CERTIFICATE OF THE SECRETARY OF ENERGY AND ENVIRONMENTAL AFFAIRS
ON THE
DRAFT ENVIRONMENTAL IMPACT REPORT

PROJECT NAME : Sierra Vista Commons
PROJECT MUNICIPALITY : Easthampton
PROJECT WATERSHED : Connecticut
EEA NUMBER : 16729
PROJECT PROPONENT : Tasty Top Development, LLC
DATE NOTICED IN MONITOR : February 23, 2024

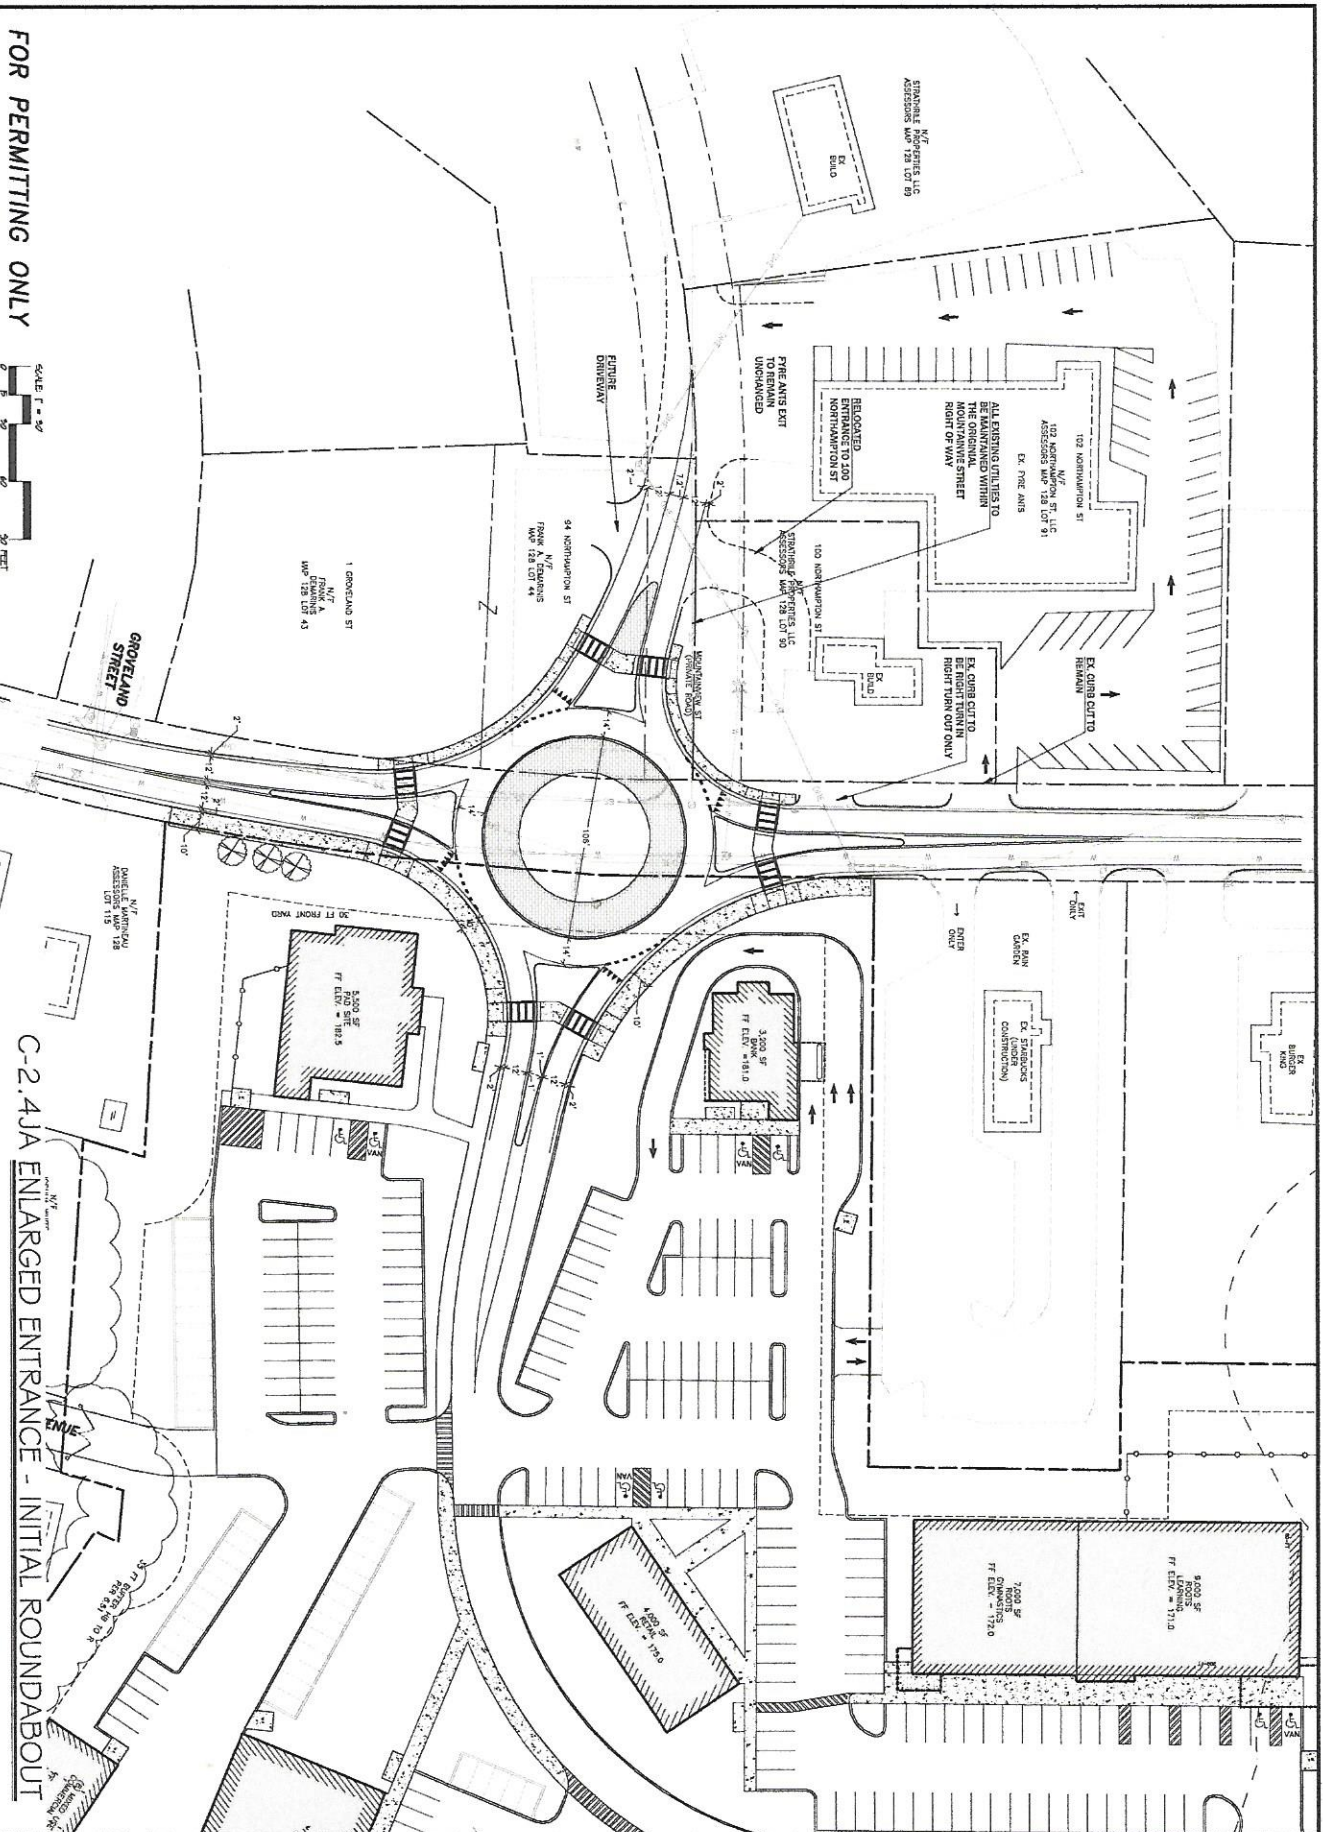
During the local review and approval process, mutual agreement was reached among the Easthampton Planning Board, the Proponent, the Cernak Family, and its reviewing agents that a roundabout design option is a preferred design solution that will accommodate the mutual safety and operating needs for public travel on Northampton Street, the Sierra Vista Commons project and the abutting properties owned by the Cernak Family. In fact, this is reflected in the November 14, 2023 Decision of the Easthampton Planning Board that is included in the DEIR filing which presents a more detailed accounting of testimony that led to that conclusion. Please see the attached drawing of the preferred design solution.

We remain concerned that any alternative to a roundabout, namely a traffic signal alternative, is not an appropriate solution; in fact, a signal would have a direct negative impact on the operations of our commercial properties, adjacent commercial properties, and the general public due to extensive vehicle queuing and driveway impacts that would result as elaborated in the local record and filings. We therefore request that the Proponent engage with MassDOT during preparation of the Final EIR (FEIR) and ultimately the Section 61 Finding process to definitively identify the roundabout alternative as the selected mitigation alternative for Sierra Vista Commons. We recognize that the roundabout alternative would require land acquisition from the Cernak Family and have indicated through ongoing discussions with the Proponent's engineering team that we would support the necessary acquisition to the extent this option is selected by MassDOT.
